Our Reference: ETP261877
LPA Reference: HGY/2026/1048
Date: 4 June 2026

Re: 18 Muswell Avenue, Hornsey, London, N10 2EG

Figure 1 – The application site and surrounding properties rear elevation

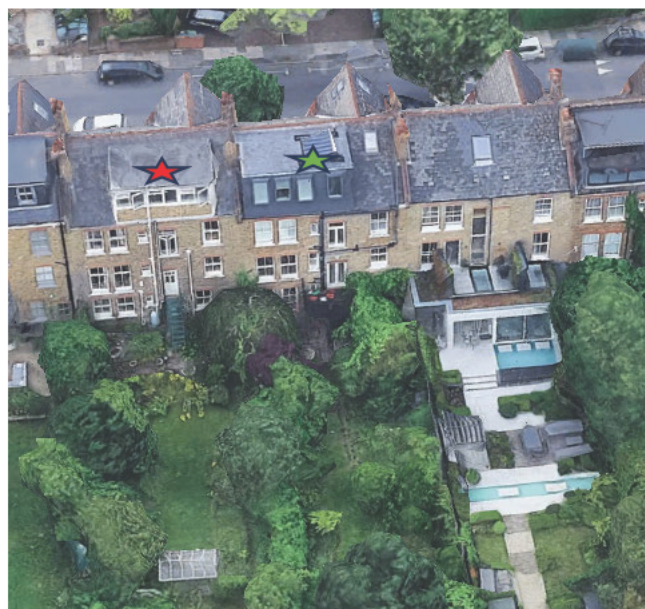
When looking at the extension, it is also important to consider the cumulative impact of the extension with other development on 20 Muswell Avenue. An aerial image of the rear elevation of these properties is shown below:

As can be seen in Figure 1, my clients' property is already bordered on one site by a neighbour's extension. If the extension which is the focus of this application is permitted in its current form this will create an overly enclosed amenity area immediately adjacent to the back of the house – further building up the perception of being 'hemmed in.' It is of note that the proposed extension is deeper than that of their other adjoining neighbour at number 22. Given there is no proposed site plan however, the contextual information available is limited.
